1415 North Tejon Street

This application proposes a covered deck addition on the rear of the existing residence.

File Number	Application Type	Decision Type
HIST-24-0005	Report of Acceptability	Quasi-Judicial

Summary of Application

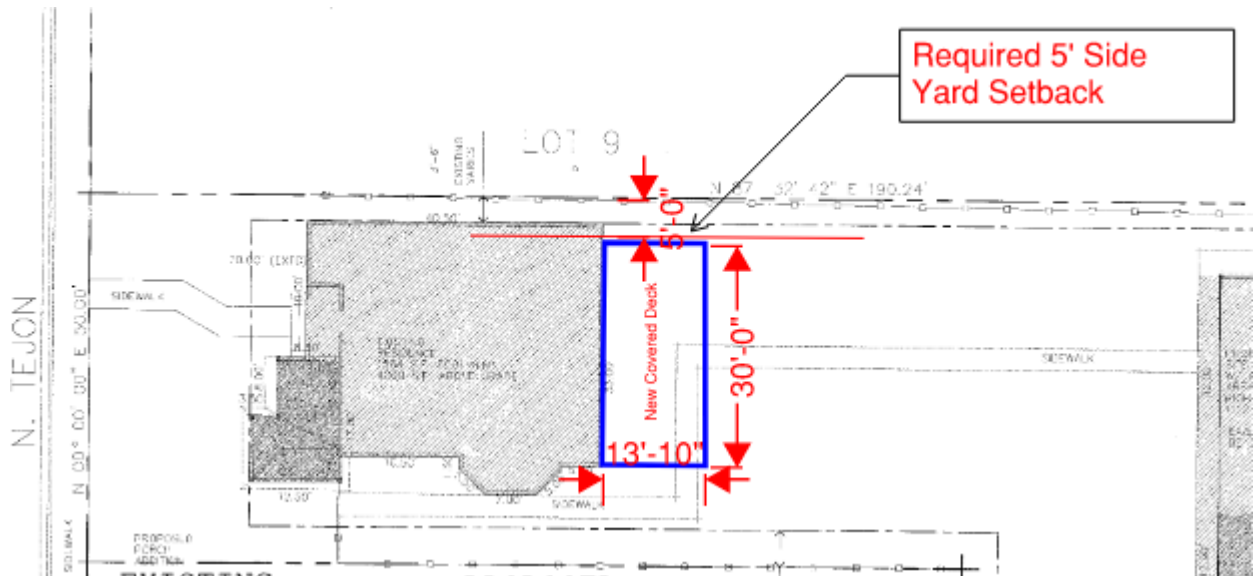
The Applicant has submitted a Report of Acceptability for a covered deck addition on the rear of the existing house located at 1415 North Tejon Street (see "Attachment 2- Project Statement and Covered Deck Plans"). The proposed deck is 415 square feet. It has been aligned with the south exterior wall of the home to meet the side yard setback standards.

The new back porch is 1-story in height and is designed with a mansard roof type. It is like the roof type that exists on the east elevation of the home. The proposed height, width and depth are compatible with the main house, and the simple design of the addition respects the character of the historic home. The rear elevation was altered sometime in the past as this home originally had a back porch. The new back porch is open on the rear and closed-in on the sides. The framing of

The new design for the rear porch is open, with appropriate scale and massing to the primary structure and its framed openings on the rear and side elevation fit with the window pattern and shapes that exist with this historic home. Most importantly, the addition has minimal visual impact on the existing structure.

- 1) Final architectural plans and elevation, and site plan are submitted showing exact location of the rear porch, roof type, and specifications for exterior material and colors. The plans are to be provided in pdf format, drawn to scale and 24" X 36" sheets.
- 2) The above referenced plans are to be submitted and stamped prior to any final inspection for the rear porch.
